February 12, 1992
LD-92-016

Subject: Response to NRC Requests for Additional Information

Reference: Letter, Structural and Geosciences Branch RAIs, T. V. Wambach (NRC) to
E. H. Kennedy (C-E), dated September 26, 1991

RESPONSE TO NRC REQUESTS FOR ADDITIONAL INFORMATION
STRUCTURAL AND GEOSCIENCES BRANCH

FINITE ELEMENT MODEL STEEL CONTAINMENT VESSEL

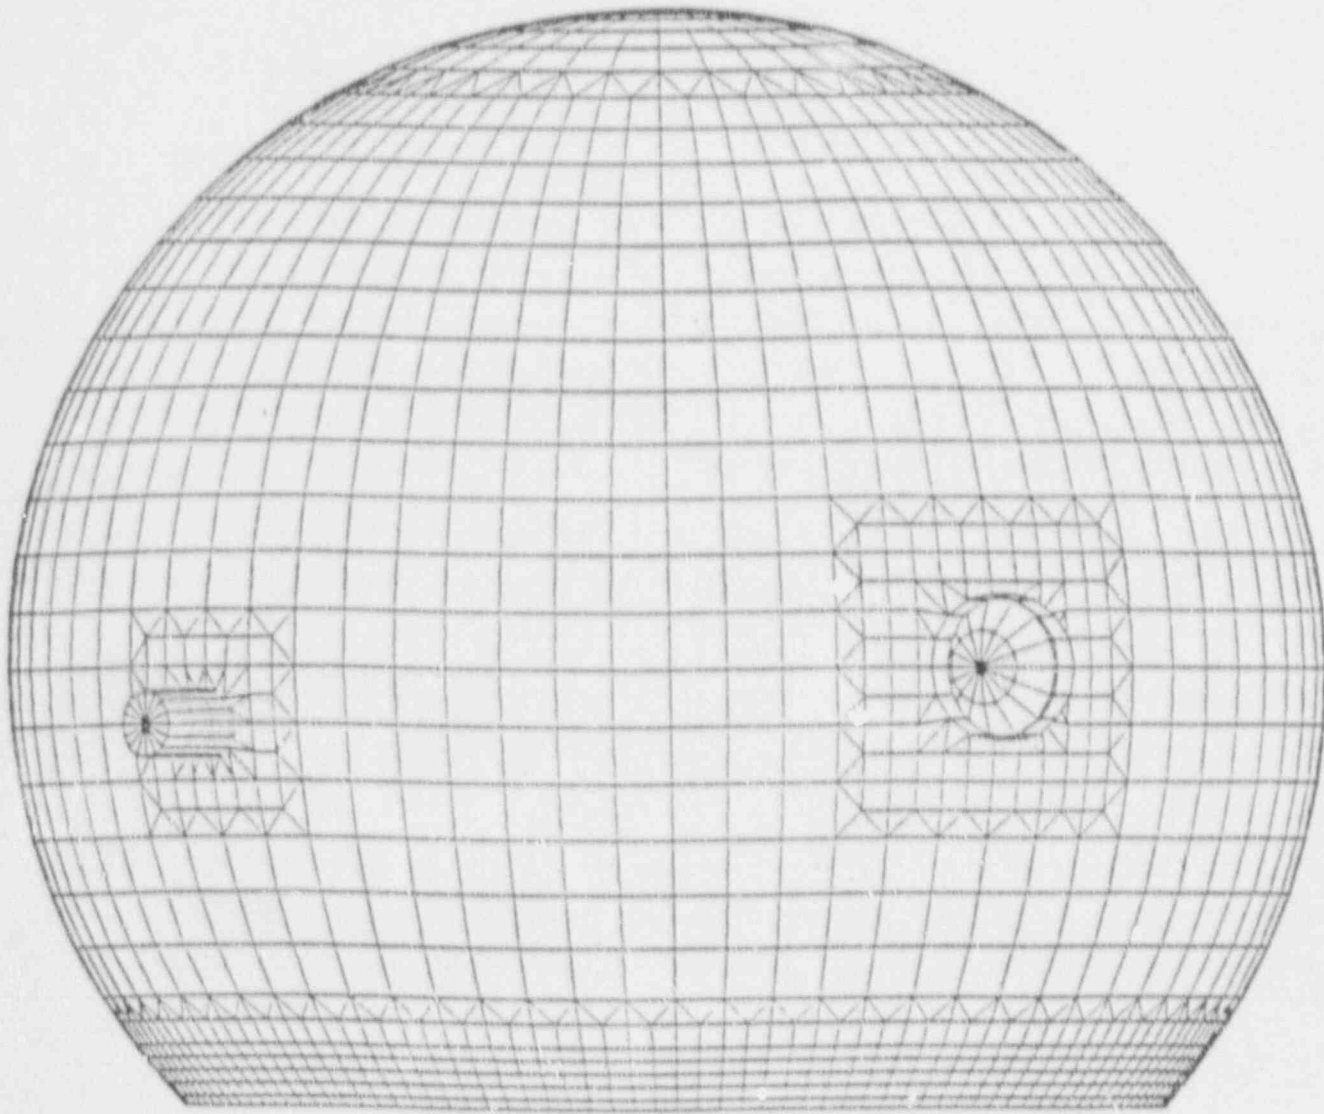
Section 3.8.2.1.2 - One of the highly stressed regions of the containment shell under seismic and thermal conditions is in or near the transition region (Sheet 3 of 3, Figure 3.8-1). Provide quantitative information to show that buckling and over-stress will not occur in this region.
